Product Change Notice (PCN)

PCN Number: PCN-0210062R-02

Product(s) Affected: SMRT-2-B

Previous Detail Image	New Detail Image

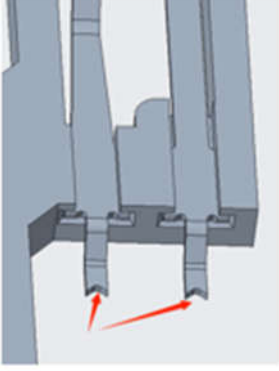
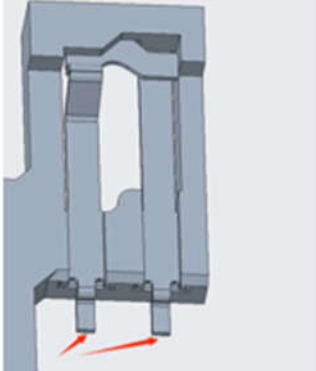
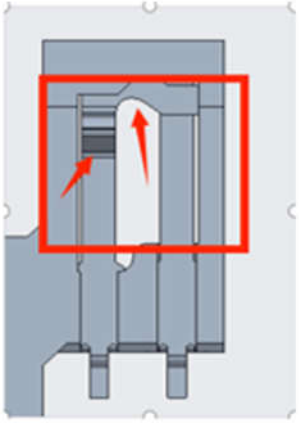
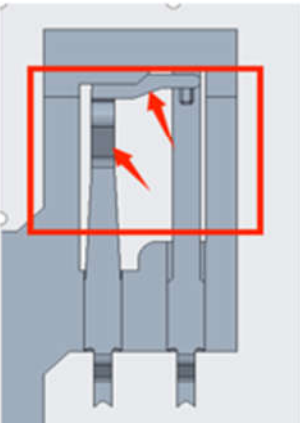
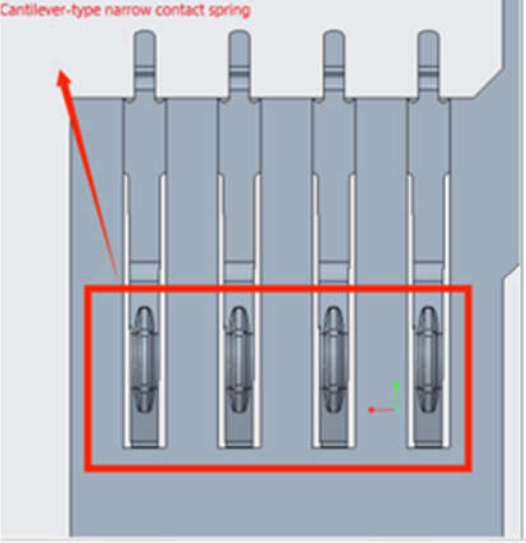
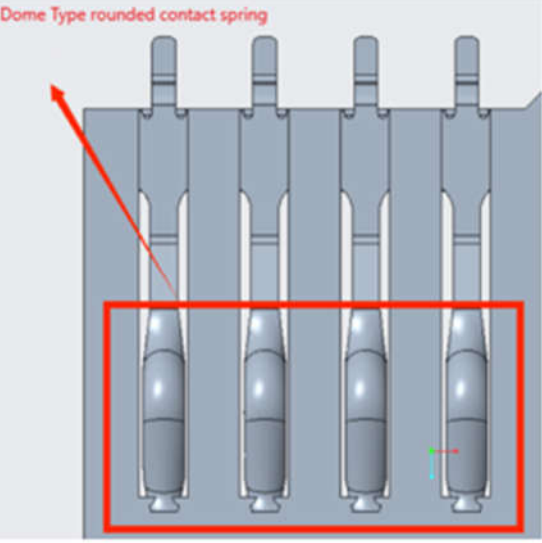
1. *Increased surface area of the switch pin solder pad*
2. *Enhanced structure of the switch pin terminal*
3. *Increased surface area on the contact terminals*

Cantilever-type narrow contact spring 	Dome Type rounded contact spring
